Title: Advisory Committee on Reactor Safeguards
ABWR Subcommittee on STP COLA

Date: Tuesday, February 8, 2011

Chapter 7

Instrumentation and Control Systems

COLA Figure 7C-1 Implementation of Additional Diversity in SSLC to Mitigate Effects of CMF

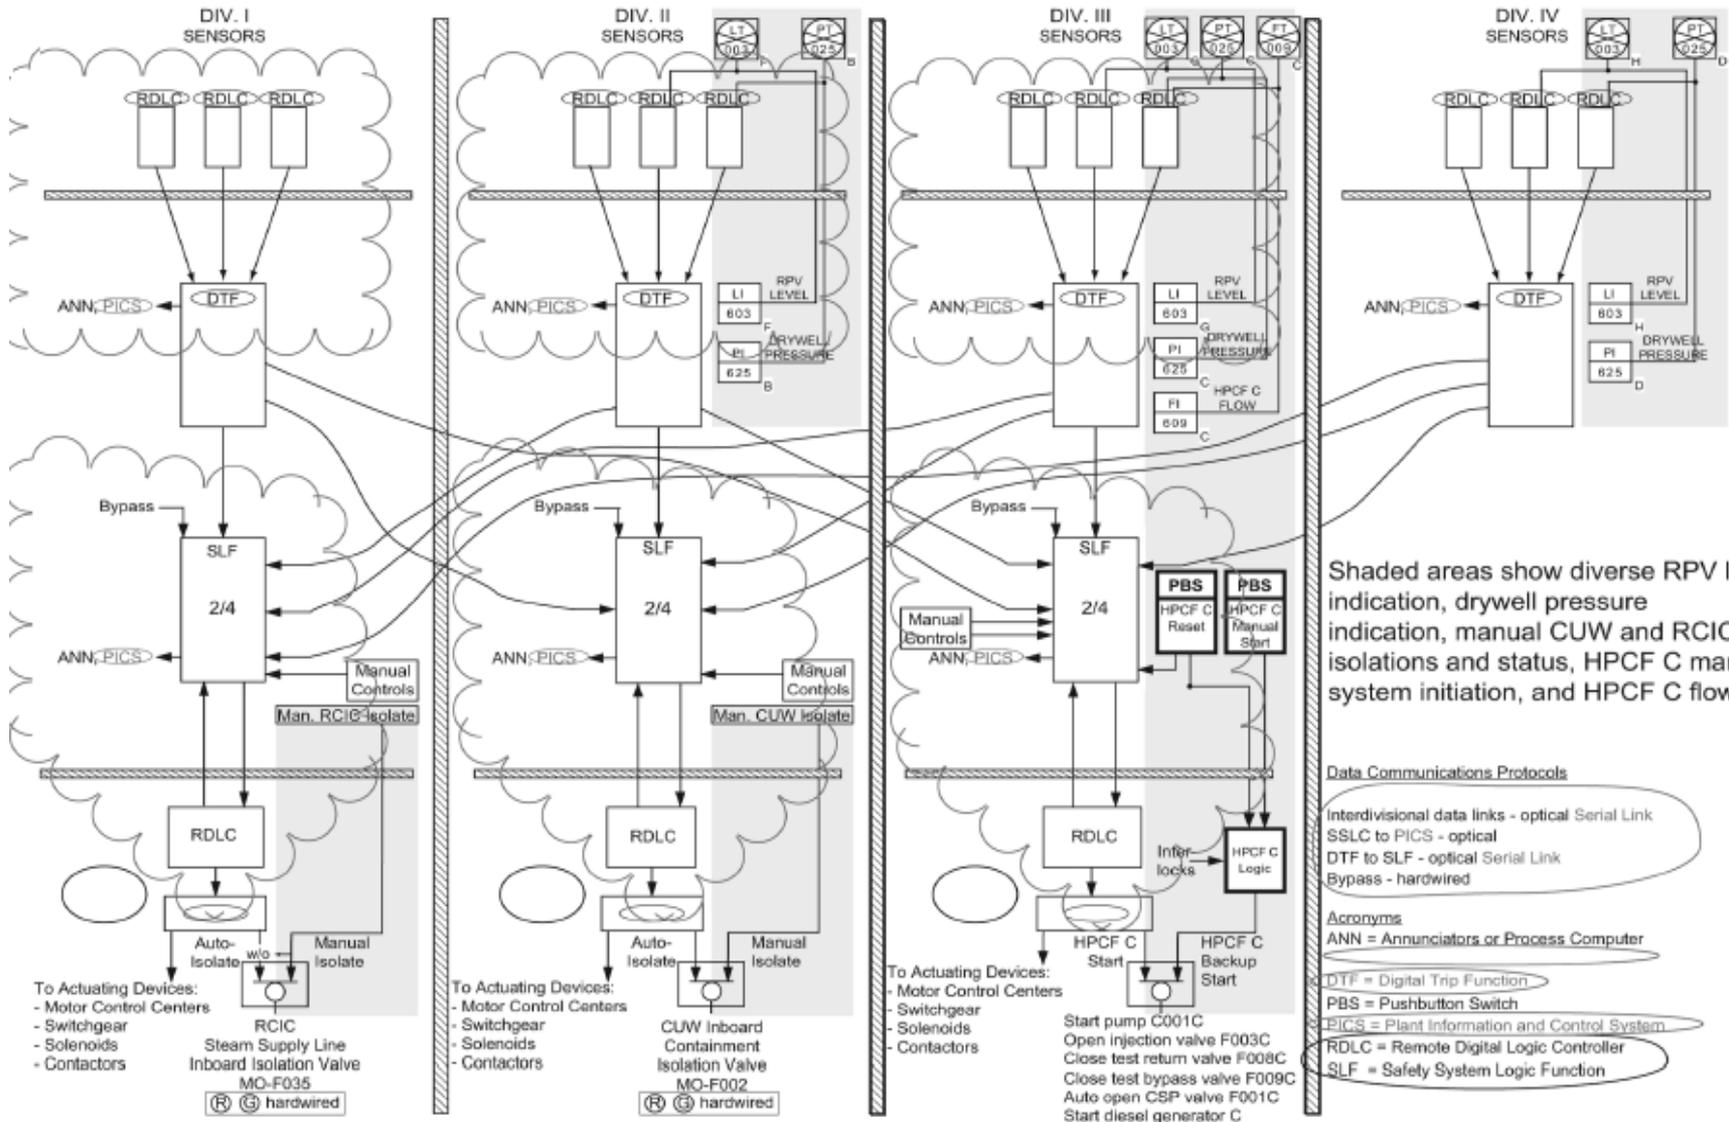
20 Now if you look at your picture at 7,
21 there's another figure you can look at also, and that
22 figure shows manual switches going to the SLF, and it
23 shows something else going down to what looks like an
24 either/or gate for the components. That's why I'm
25 asking the question.

22 MEMBER BROWN: So there's a nuance. If I
23 look at Figure 7C-1, where that -- in other words,
24 there's a set of manual controls that go into the
25 SLFs, and then there's another set of manual controls

9 MEMBER STETKAR: Only that's not what this
10 drawing says.

3 CHAIRMAN ABDEL-KHALIK: Thank you. Before
4 we take a break, I think we ought to capture the
5 briefings that you need to clarify. Number one,
6 you're going to go back and look at Figure 7C-1, 7C-1
7 to try to answer John's question; is that correct?

2 MR. MURRAY: I'd like to see the figure.
3 Let me make sure I understand it. That is correct, in
4 that the SLFs -- in other words, operator ability to
5 control the component from the control room, he has
6 the ability to start and stop it with logic that's
7 carried out through the ESF -- ELCS system basically.

5 The logic will change to the other logic
6 channel, one out of one. So that the system level
7 controls will still operate. The manual control, an
8 individual component with a flat screen display, soft
9 control, that does not go through the SLF. The SLF is
10 for system level functions.

- Specific items of interest (continued)
 - In STP 3 & 4 I&C design, the hard wired diverse features are independent of all digital I&C systems as illustrated in STP 3 & 4 FSAR Figure 7C-1.
- Conclusion
 - Although STP 3 & 4 I&C design has reduced concerns with CMF in digital I&C systems, it incorporates diverse backup design features of the certified ABWR design with no departures.
